The Hall School
23 Crossfield Street, London NW3
Basement Impact Assessment
Audit

For
London Borough of Camden

Project Number: 12985-37

The Hall School, Hampstead – Planning Application 2019/1325/P – BIA Audit D1

Figure 4: Existing basement wall construction

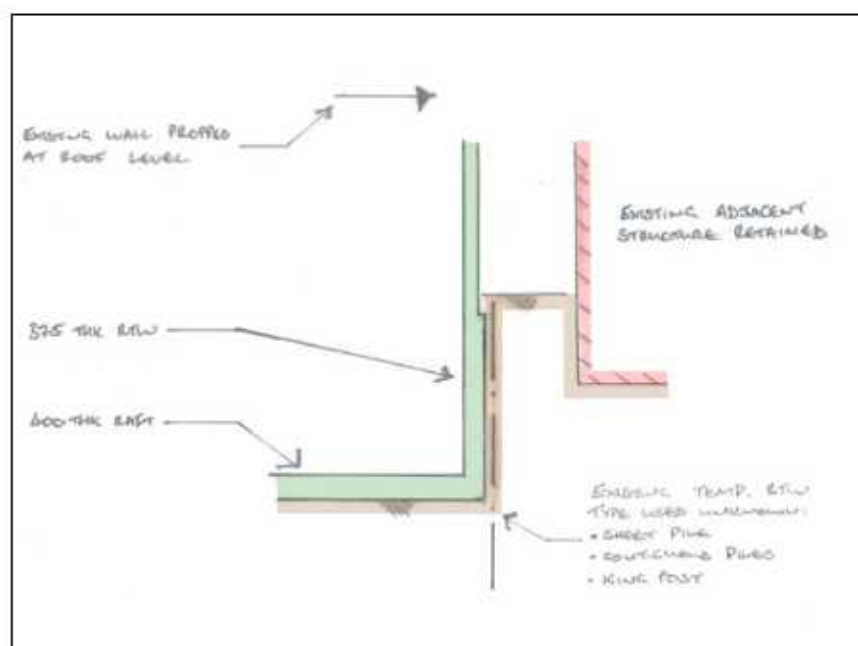
- 4.9. In the initial audit it was noted that the GMA did not consider the impact of possible movement of the existing retaining walls resulting from the removal of the permanent prop. It has since been confirmed that the scheme has been revised so that the retaining wall is propped in the temporary and permanent cases. The GMA is therefore accepted.

1. **GMA does [not] consider removal of permanent props from the existing basement wall (Refer to CR Audit – 4.8)**

The profile of the existing basement wall suggests it could have been designed as a cantilever. Archive drawings show that the wall from basement to the ground level is 375mm thick and above this is 250mm thick (see attached Archive drawing). If this is the case, when the wall is cut down the remaining section will continue to act as it does in the existing case.

However, as we are currently unable to prove this by knowing the amount of reinforcement in the basement, therefore we have taken a conservative approach and assumed the wall was designed as a propped cantilever. Since the *BIA 2190008 Hall School - EW Planning Report 190311* was issued in April 2019 we have added in a permanent prop at ground level to keep the proposed condition of the wall as similar as possible to the existing. A beam now spans along the top of the wall and connects into the columns that support the floors above the basement, this system will provide lateral restraint to the top of the wall.

There will be a change in stiffness from the existing condition to the proposed case therefore the capping beam will be pre-loaded in order to minimise movement once the temporary props have been removed.
